# Solicitation

NUMBER
DEFK13002

**WVARNG Buckhannon Readiness Center DEFK13002  
BID FORM - SECTION I (REVISED)  
(Base Bid and Alternates)**

SHEET: A-2.1

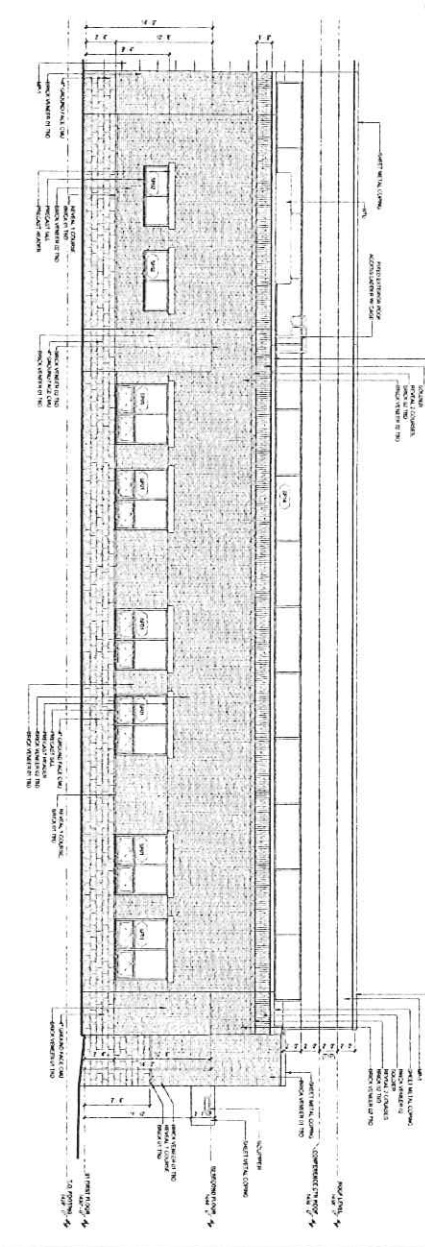
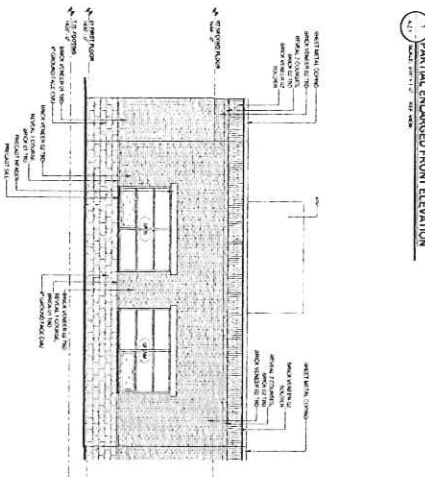
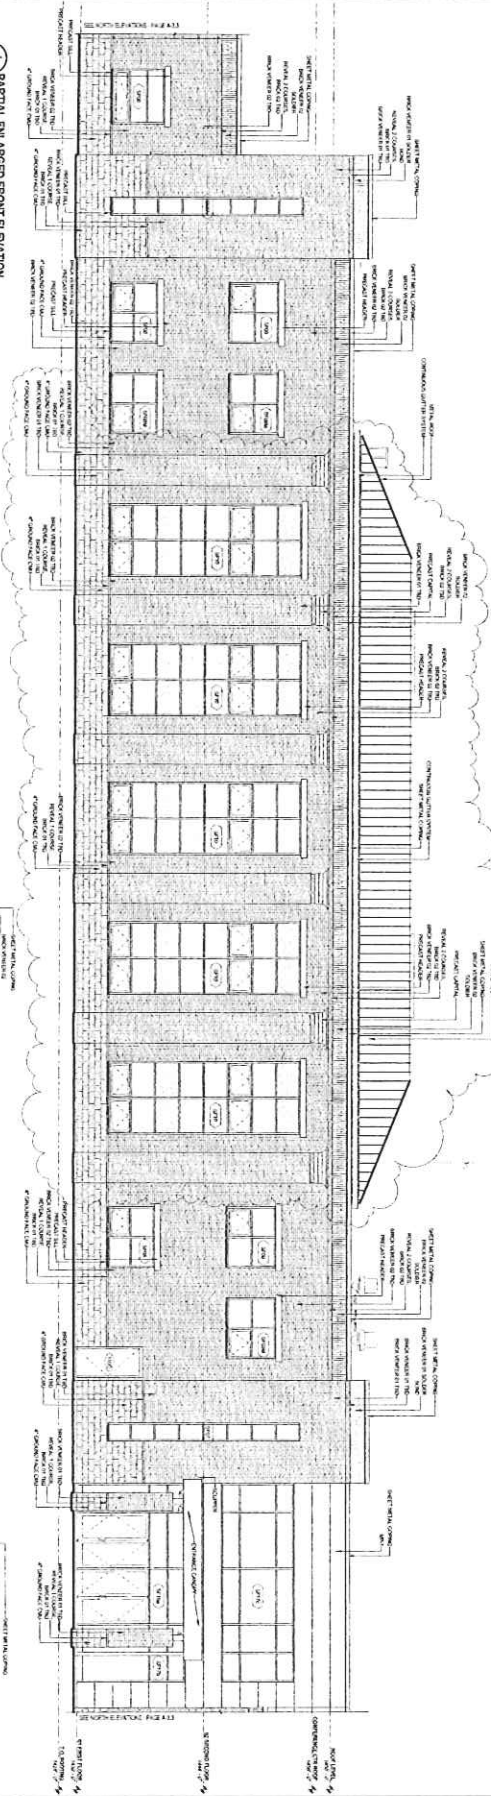
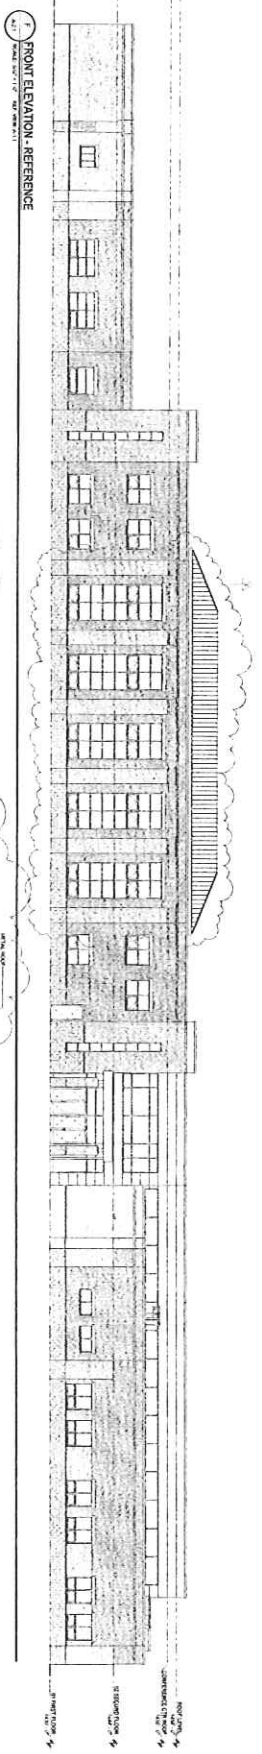
**Drawings:****Addendum 01 - Item 14. Drawing A-2.1:**

- a. **DELETE** Pre-Cast Entablature on front elevation along with the structural steel. See Enclosure A-2.1
- b. **REPLACE** Ground Face CMU at the base of wall for the entire building perimeter with Matte Face CMU.
- c. **DELETE** Pre-Cast Banding where indicated on Drawing A-2.1. See Enclosure A-2.1
